# Access Compliance Report

## Public Rights-of-Way

### (Curb Ramps)

Intersection ID: N/A	Main Street: MILLENNIUM_AV	Cross Street: ANSLEY_GARDEN_DR	Location: SW
ADA ID: 457108C487DC	Ramp Type: Directional1	Initial Pass/Fail: Fail	Overall Compliance: No
		Severity Score: 1.25

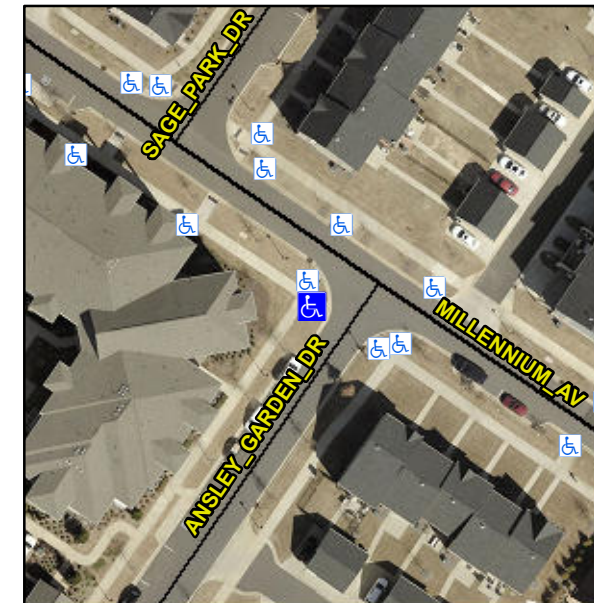
**R304.5.3**

Compliance	Description	Data	Compliance	Description	Data
N/A	Ramp Length (in)	110.0	N/A	Grade Break?	N/A
Yes	Ramp Width (in)	70.0	N/A	Grade Break Slope (%)	0.0
Yes	Ramp Slope (%)	5.8	N/A	Grade Break XSlope (%)	0.0
No	Ramp XSlope (%)	2.6			
N/A	Flare Type LT	N/A	N/A	Flare Type RT	N/A
N/A	Flare Slope LT (%)	N/A	N/A	Flare Slope RT (%)	0.0
N/A	Flare Traversable LT?	N/A	N/A	Flare Traversable RT?	N/A
N/A	Landing Length (in)	0.0	N/A	DWS Provided?	N/A
N/A	Landing Width (in)	0.0	N/A	DWS Contrast?	N/A
N/A	Landing Slope (%)	0.0	N/A	DWS Length (in)	N/A
N/A	Landing X Slope (%)	0.0	N/A	DWS Full Width?	N/A
N/A	Landing Curb? (Y/N)	N/A	N/A	DWS Offset LT (in)	N/A
N/A	Shared Landing?	N/A	N/A	DWS Offset RT (in)	N/A
N/A	Gutter Ponding?	0.0	N/A	Gutter Slope (%)	N/A
N/A	Gutter Lip Ht (in)	0.0	N/A	Gutter X Slope (%)	N/A
N/A	Painted X Walk1?	No		Road Slope (%)	0.5
	X Walk 1 Direction	To SE		Road X Slope (%)	2.9
	X Walk 1 Width (in)	N/A		Clear Space?	N/A

**Remove & Replace Entire Ramp.**
